# STAFF REPORT TO PLANNING COMMISSION

**SUBJECT:** **Semiahmoo Zone 3**

**APPLICATION TYPE(S):** Planned Unit Development and Preliminary Plat

**FILE NUMBER(S):** PUD-2-16 and LOP-1-16

**Figure 5**  
Southeast Project Edge

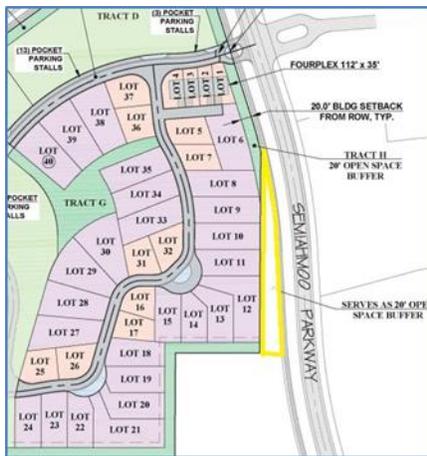
On the eastern boundary adjacent to Semiahmoo Parkway there is a unique situation where a narrow strip of land exists between the site and the parkway (Figure 5). This strip is about 40 feet wide at the widest point and tapers to a point. This strip of land occupies about 40-percent of the total project frontage on Semiahmoo Parkway. The parcel is effectively undevelopable due its narrow width and overall development restrictions. It is held under separate ownership (i.e. not owned by the project proponent). The project proponent proposes that this strip of land be permitted to serve as a buffer to the parkway and that the project not be required to provide a second buffer which in essence would be a buffer to a buffer. With this exception, the project design complies with the landscape area, buffering, and setback standards for a PUD under the BMC. A finding or condition of approval should address the missing buffer and strip of land along the parkway. In staff’s opinion the request
